CALIFORNIA COASTAL COMMISSION

STAFF REPORT: PERMIT AMENDMENT

APPLICATION NO.: **1-89-028-A3**

DESCRIPTION OF
AMENDMENT REQUEST: Enlarge the building envelope for the 10.6-acre
parcel at the southern end of the subdivision to
18,000 square feet and relocate the building
envelope southwesterly from 75 feet to within 35
feet of the coastal bluff.

EXHIBIT NO. 3
APPLICATION NO. 1-89-028-A3
MEREDITH
SITE PLAN

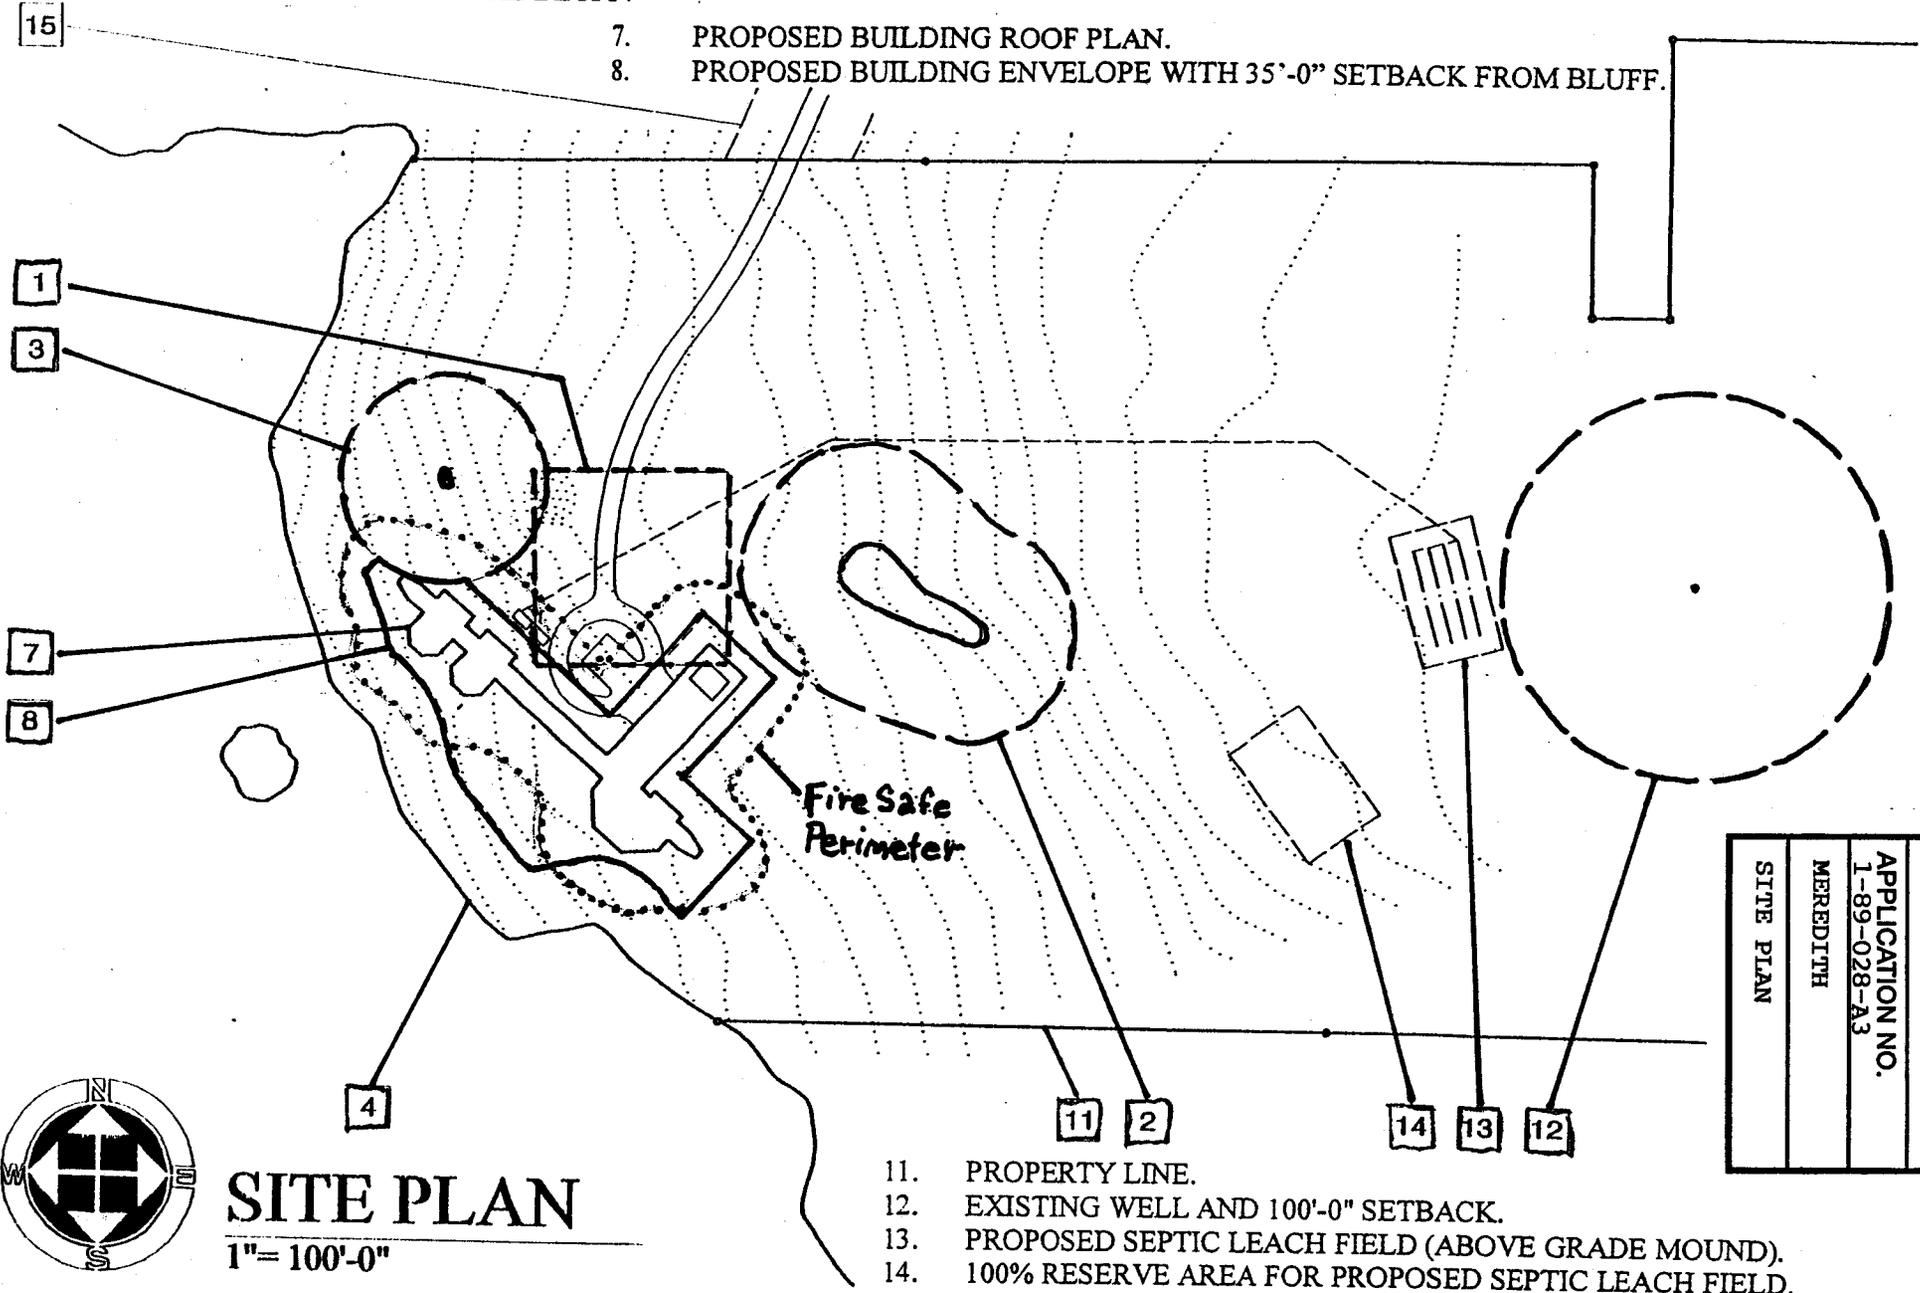
The configuration of the proposed revised building envelope is shown in Exhibit 3. The applicant indicates that the purpose of moving and reconfiguring the building envelope is to accommodate a larger house and enable the future home to be built on the site to take advantage of the scenic whitewater and blue water views to the southwest, which include views of the headland occupied by the Jug Handle State Reserve.

Pages 1-5 of Exhibit 4 show the proposed relocated and expanded building envelope superimposed against a diagram showing the existing trees. The trees are shown as dots that range in size to reflect the relative sizes of the trees in each location. The exhibit shows that many existing trees are located within the proposed expanded and relocated building envelope and that only a relatively small number of trees, and generally only smaller trees, are located outside of the proposed building envelope on the side facing Jug Handle State Reserve. Approval of the envelope would establish the expectation that future coastal development permit applications would be approved for removal of trees and development of a home anywhere within the confines of the building envelope. The proposed expanded and relocated building envelope could accommodate many possible building layouts for a single-family home and additions that might be proposed in future years. Building layouts constructed utilizing all or just the southwest side of the building envelope would be prominently visible from Jug Handle State Reserve and would eliminate this edge of the forest as viewed from the Reserve. Even a building layout that would leave some room between the building and the southwest side of the building envelope, such as the layout proposed by the applicants in their concurrent application for a house, Appeal No. A-1-MEN-01-051, would displace much of this portion of the pine forest because of the need to comply with the Fire Safe Regulations (FSR) of the California Department of Forestry and Fire Protection (CDF). These Fire Safe Regulations of CDF are directed at maintaining defensible space. The defensible space regulations require removal of flammable vegetation within 30 feet of any structure, including all brush, all dead branches within 10 feet of the ground and all dead trees within 30 feet of structures. The arborist's report prepared for the proposed permit amendment and related appeal indicates that a number of trees within the building envelope are dead or dying and thus would need to be removed to meet the Fire Safe Regulations. Furthermore, establishing a building envelope that comes to within 35 feet of a bluff edge where there are magnificent ocean and coastal views would likely encourage occupants of any home built there to try to take advantage of those views by clearing and limbing trees that would otherwise block these views from the structure's windows. Because the view that would be gained by any permissible tree limbing and vegetation clearance would look out at

EXHIBIT NO. 4
APPLICATION NO. 1-89-028-A3
MEREDITH
PROJECT PLANS (1 of 14)

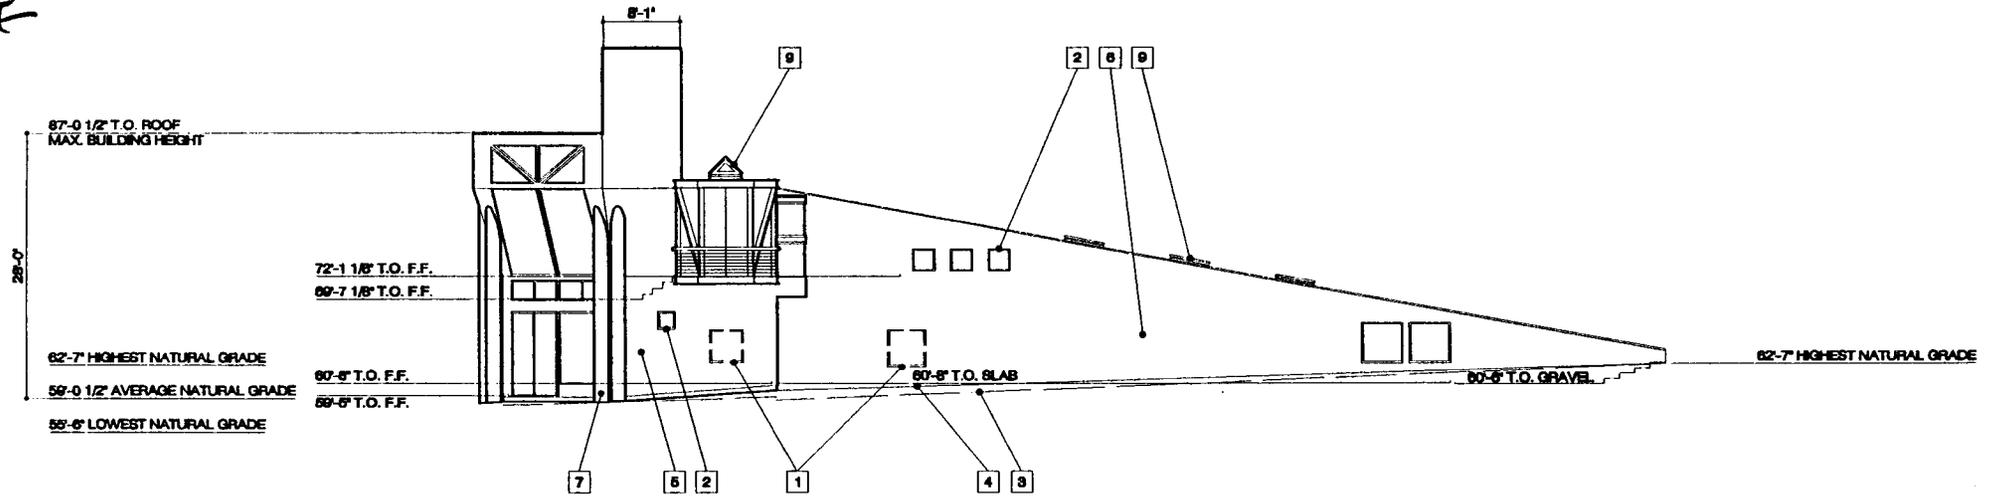
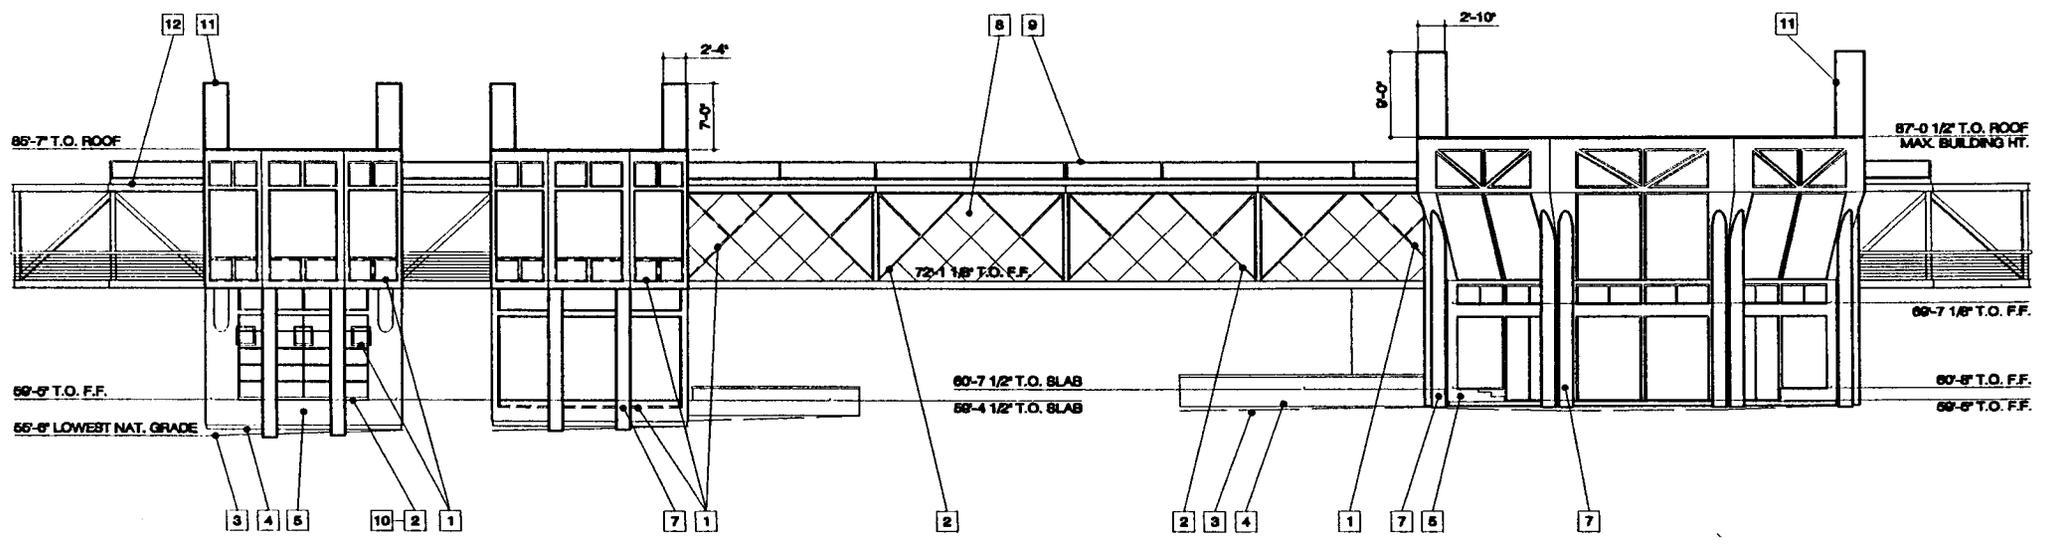
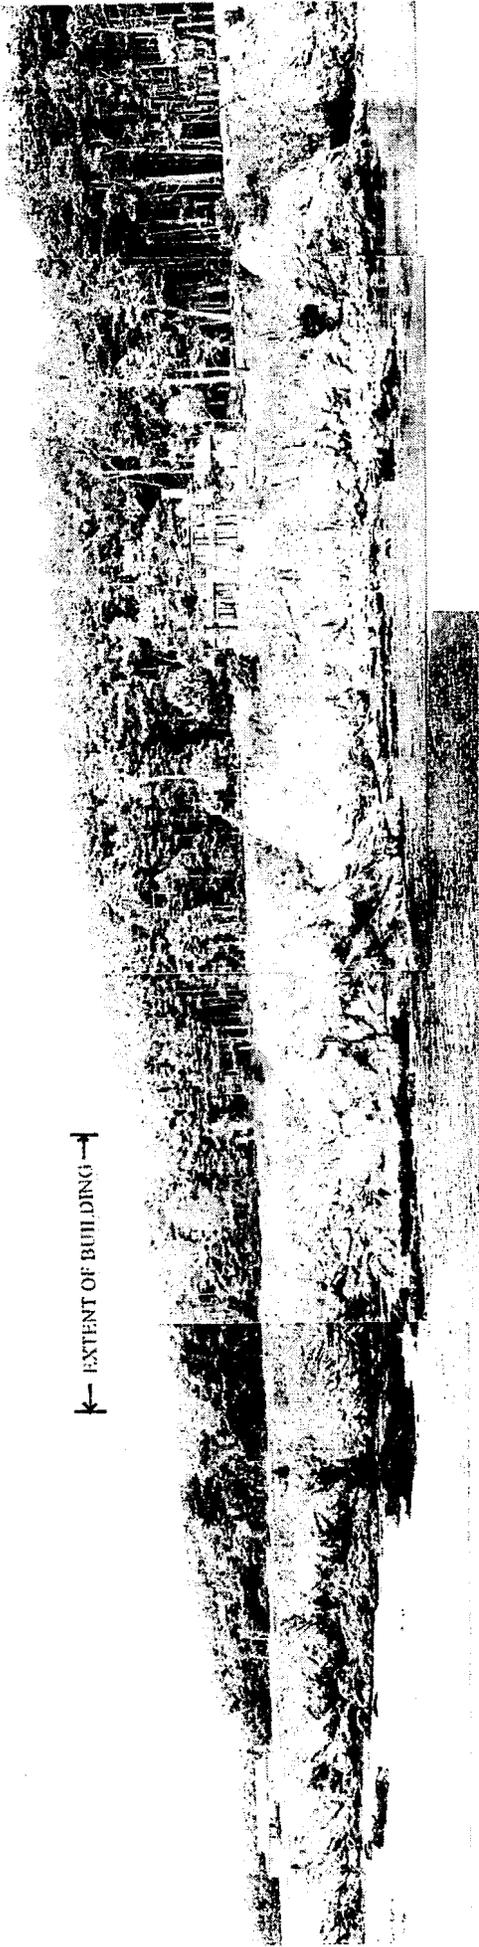
The particular configuration of the building envelope proposed would also encourage development of a structure that could have a large expanse facing the public viewing areas at Jug Handle State Reserve in comparison with the other houses within the subdivision. The southwest side of the proposed expanded and relocated subdivision, the side facing the State Reserve, would be the longest side of the irregularly shaped envelope. From end to end this side of the envelope would measure 230 feet long. In contrast, the sides of the generally square building envelopes currently established for this parcel and the others within the subdivision are approximately 100 feet in length. Thus, the proposed expanded and enlarged building envelope

State Parks staff met with the applicant and agents and reviewed the plans on December 20, 2000, following which our staff visited the site to assess visual impacts. The agents assured us at that time that no more than nine small trees would be removed to accommodate the project. The building dimensions were not defined on site, nor do the plans submitted to us indicate the intended bluff setback or any building dimensions. It is surprising that even now no story poles have been erected to provide a clear indication of the potential visual impacts, particularly of the southwestern façade 210 feet in length and 28 feet in height, with six 37-foot vents.
